CENTRAL MAINE POWER COMPANY
Application for Site Location of Development
Act permit and Natural Resources Protection
Act permit for the New England Clean Energy
Connect (“NECEC”)

SITE LAW CERTIFICATION SLC-9

SURREBUTTAL TESTIMONY OF GROUP
4 WITNESS Dr. ARAM J.K. CALHOUN

SURREBUTTAL TESTIMONY OF GROUP
4 WITNESS
Jeff Reardon

10/30/2007 Image: Pre Capital Road Re-alignment

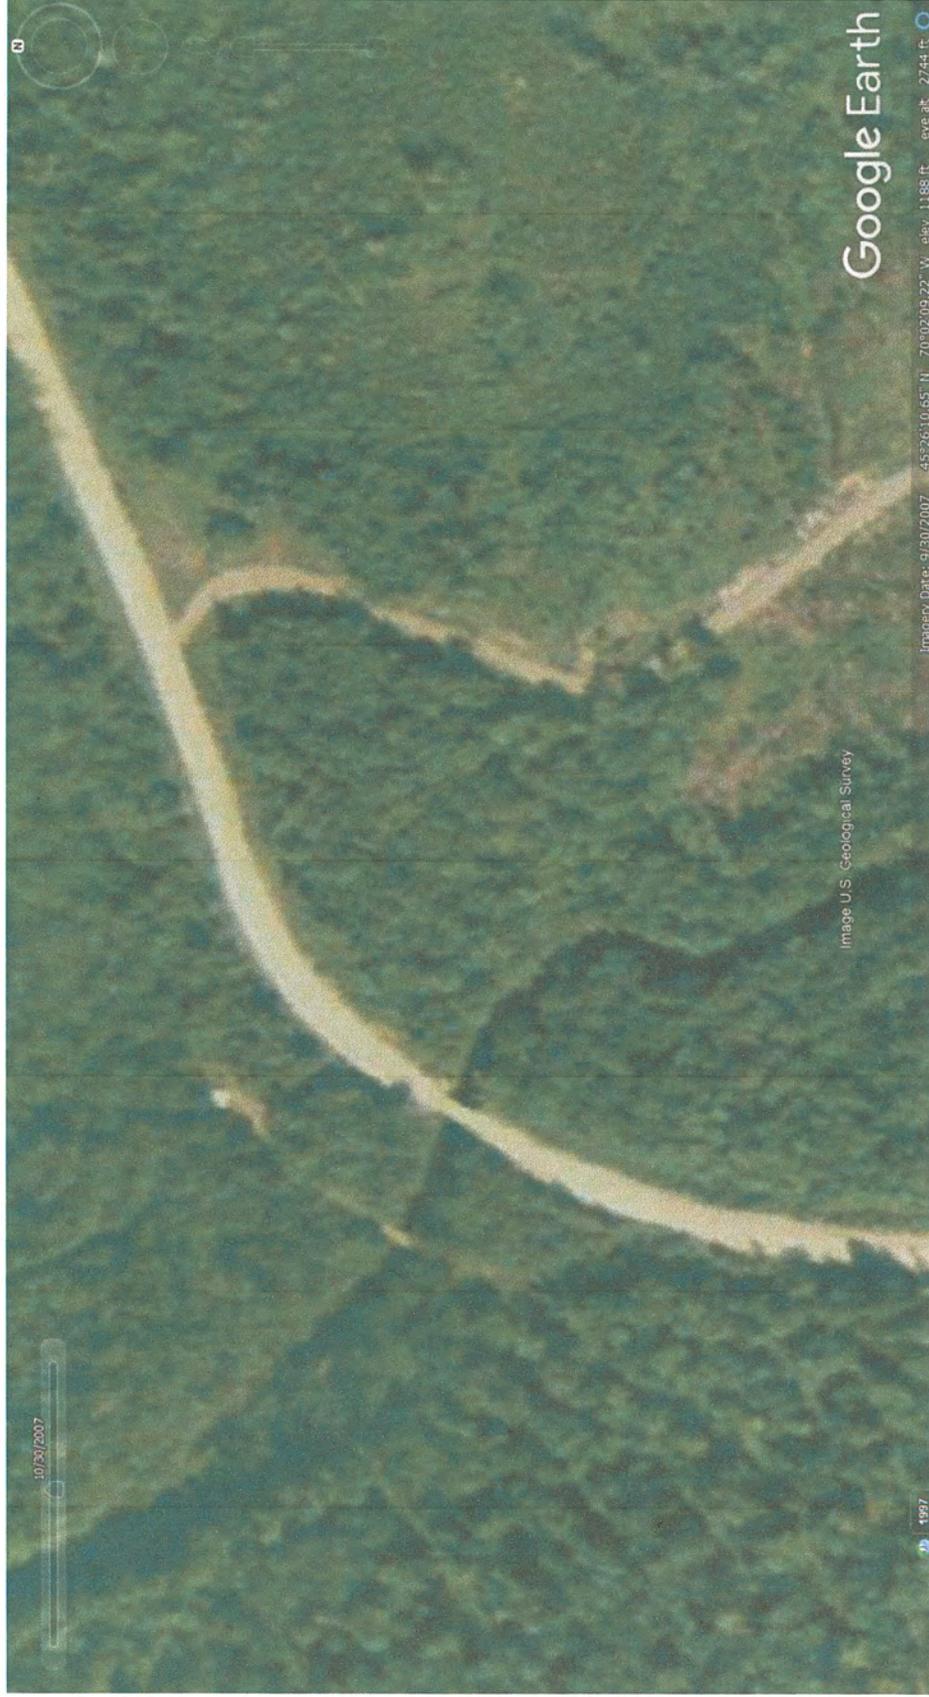
Based on photos available on Google Earth, it has been at least 8 years since the Capital Road was re-aligned and a new bridge constructed. An image dated 10/30/2007 shows the old alignment. One dated 11/25/2011 shows the site soon after the new bridge was constructed. The most recent image, from 4/23/2016, shows minimal revegetation of the old road corridor. These three photos are displayed as Attachment 1 to this testimony. On the 4/23/2016 image, the center line and clearing limits of the NECEC (from the Google Earth layer maintained at the Maine DEP GIS portal) are superimposed on the image, showing that what little forest canopy remains in this area will be removed when the NECEC line is constructed. I agree with the Mr. Freye’s assessment that the existing conditions at the Capital Road crossing of Cold Stream are “very open” and that “tree cover is sparse” because of past disturbances, most recently the road re-

alignment. But based on both the evidence from aerial imagery and from personal experience at the site, I disagree that we can expect the area to “revegetate quickly with alders and other non-capable species.” It has been at least eight years since the Capital Road was re-aligned, and we’ve seen little or no revegetation on the former road bed. Based on measurements from Google Earth of the existing conditions, the “very open” condition Mr. Freye notes results from two cleared areas that are approximately 40 feet wide at the old Cold Stream crossing, and approximately 65 feet on the new crossing. As shown in the photo where the NECEC clearing limits are overlaid on existing conditions, that will expand to about 250 feet of cleared area after the NECEC is completed, more than doubling the existing impacts that Mr. Freye notes. These impacts could be avoided with taller poles that allow for full canopy vegetation, but Mr. Freye does not discuss this option.
